CITY OF CONWAY, ARKANSAS PLANNING COMMISSION

January 19, 2021 • 7:00pm

Request for Preliminary Plat Approval - Twin Rivendale Subdivision, Phase 1

Request for Preliminary Plat Approval - Southcrest PUD Subdivision

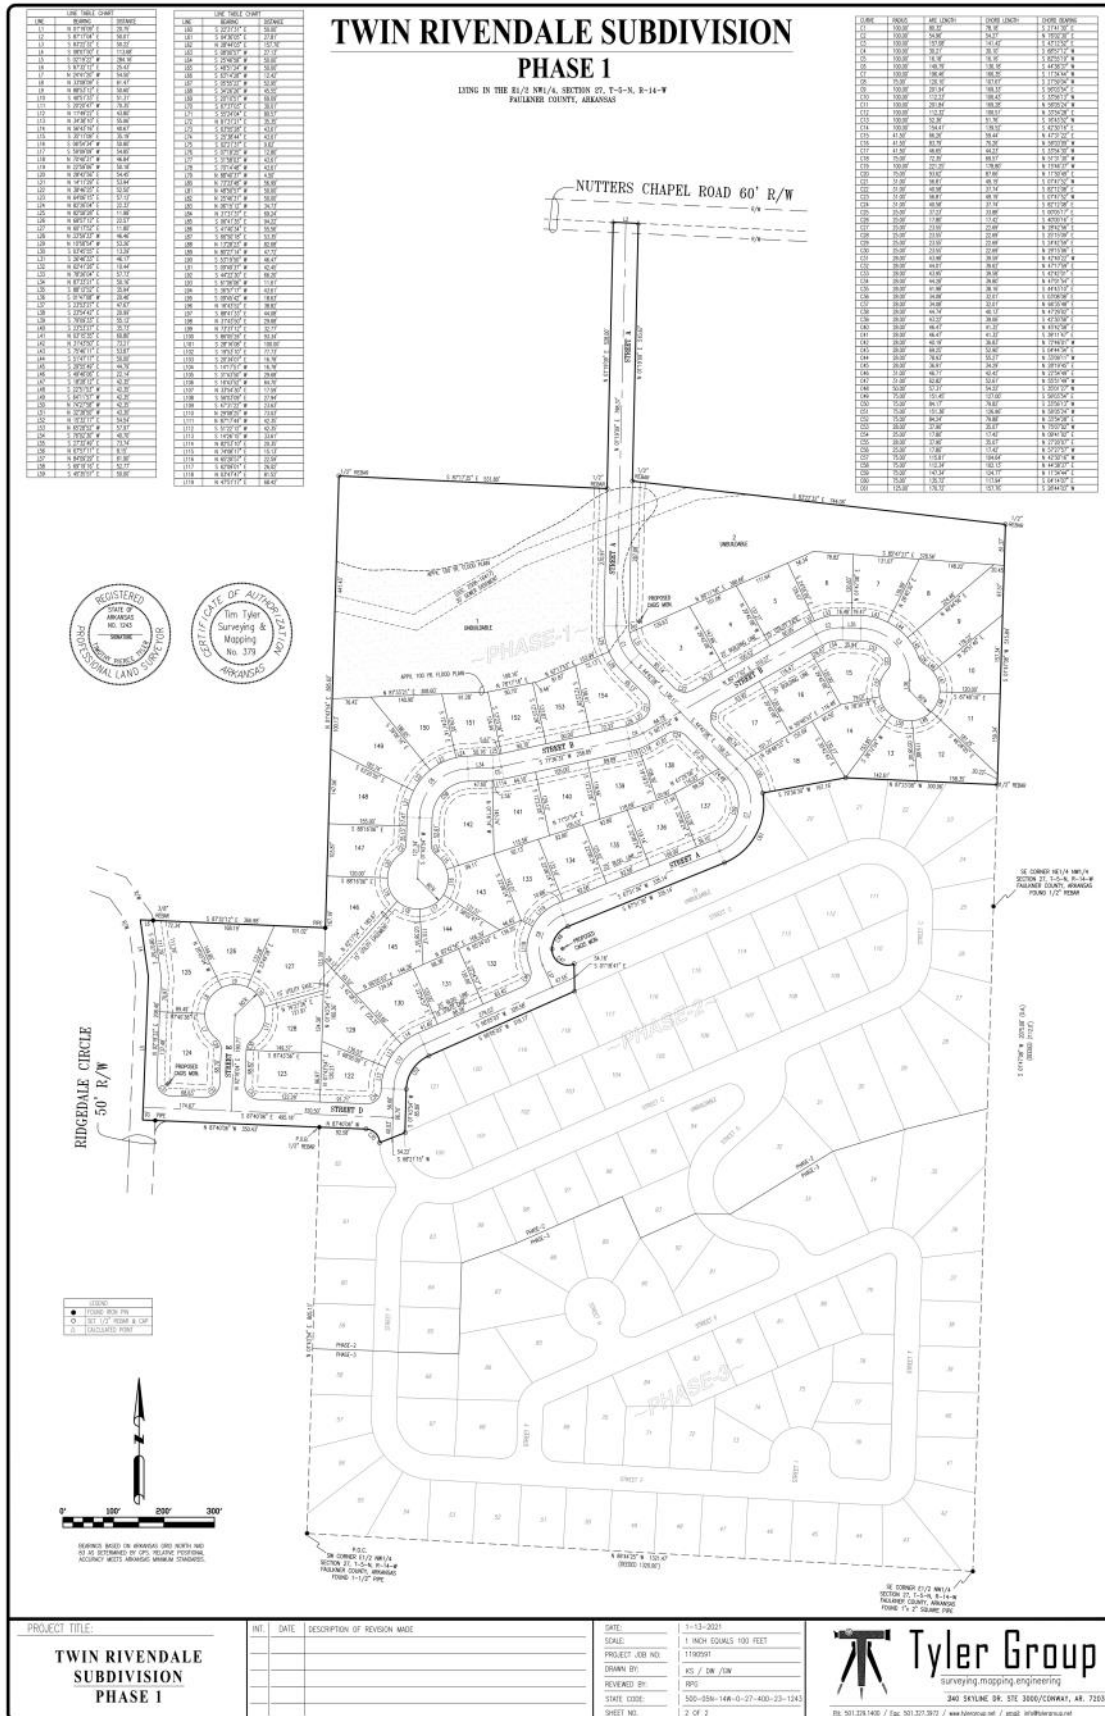
1. Show all hydrant locations.
2. Corrections as noted on Preliminary Plat.
3. Add 'Trail Easement' to entire area designated for Sewer Easement.

Request for Preliminary Plat Approval - Southcrest Subdivision

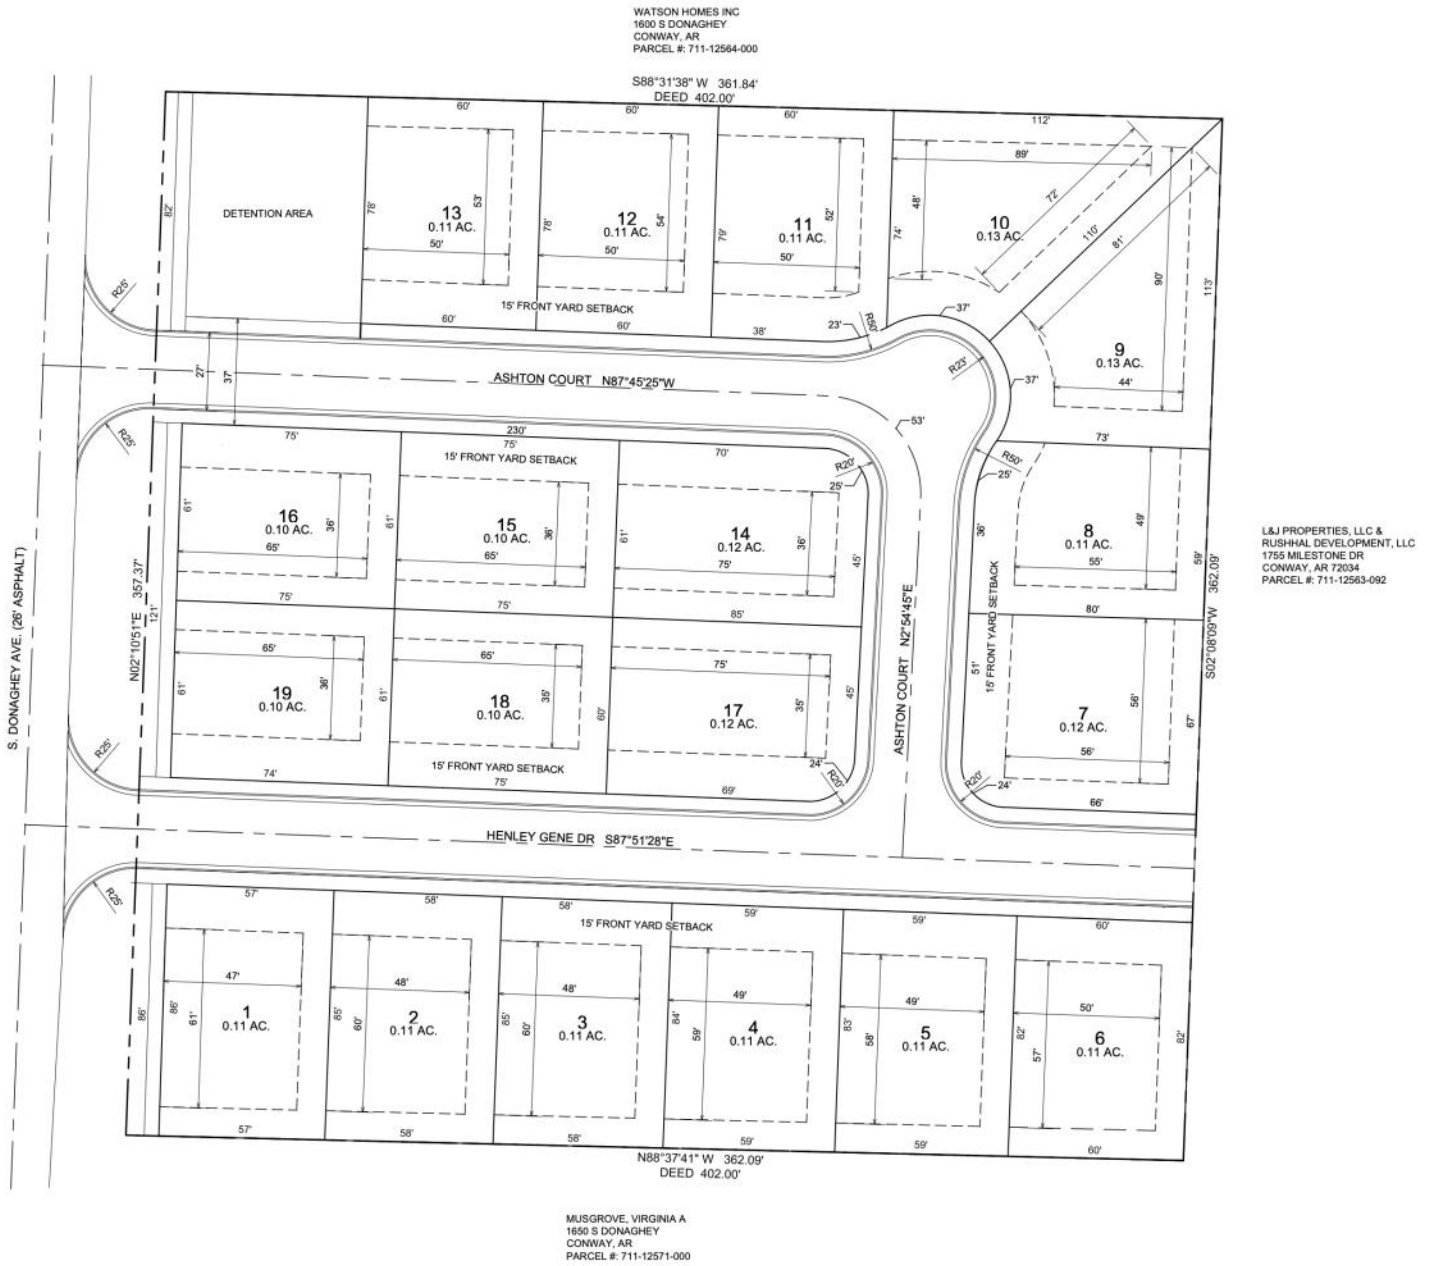
1. Show all hydrant locations.
2. Corrections as noted on Preliminary Plat.

4. The sidewalk along S Donagey Ave shall be revised in width to meet the minimum requirements of the Master Street Plan or an alternative design approved by the Transportation Department.

Request to Rezone: R-1 to PUD

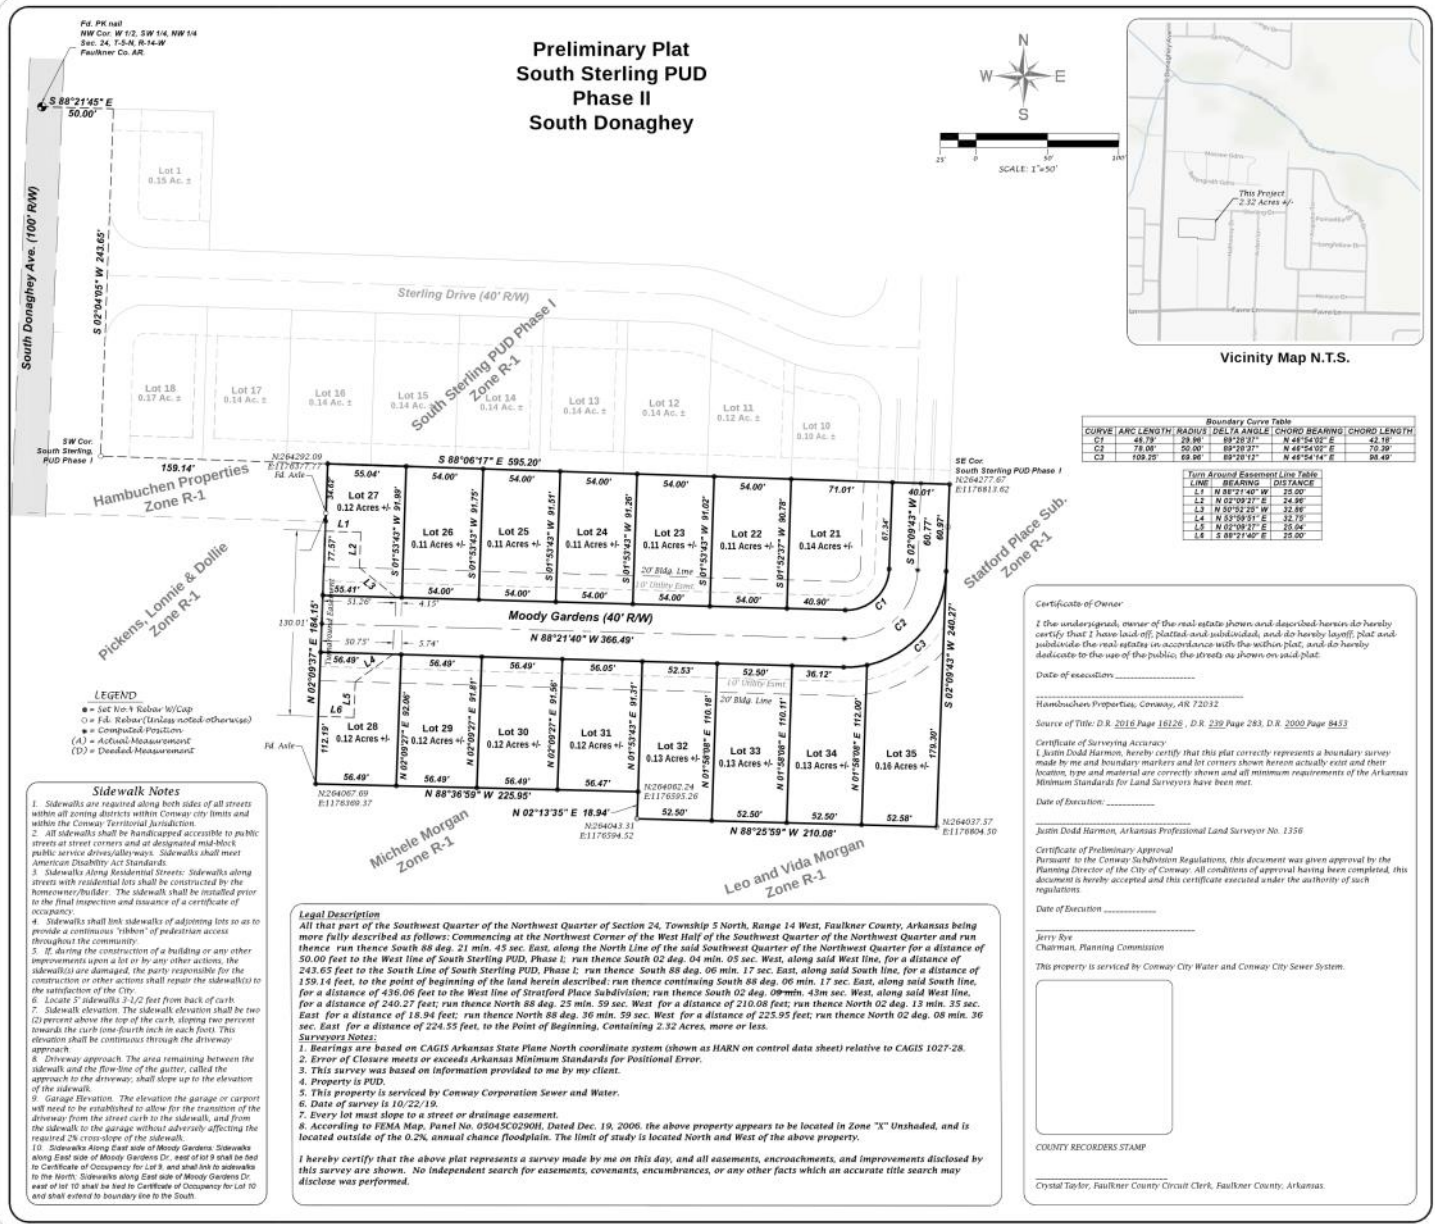
- The applicant is requesting a rezoning to PUD for the purpose of developing a second phase, consisting of 15 lots, of an existing PUD.
- Access to the development is proposed as an extension of Moody Gardens. As the street currently exists as a local residential street of 50' public right-of-way the extension shall be the same. Reduced right-of-way creates challenges with installing utility and sidewalk improvements.

- The extension of Moody Gardens shall be designated as a private drive.
- The proposed hammerhead style turnaround proposed on lots 27 and 28 must be constructed and those lots left otherwise undeveloped until future connection to S Donaghey Ave is established.

14. The extension of Moody Gardens shall be dedicated as 50' public right-of-way and constructed as a Local Residential Street in accordance with Conway Transportation Department standards.

15. An approved fire apparatus turn around shall be constructed in accordance with the Subdivision Regulations, prior to issuance of building permits.
16. Applicant shall return a signed copy of the final development plan agreement prior to the issuance of building permits.
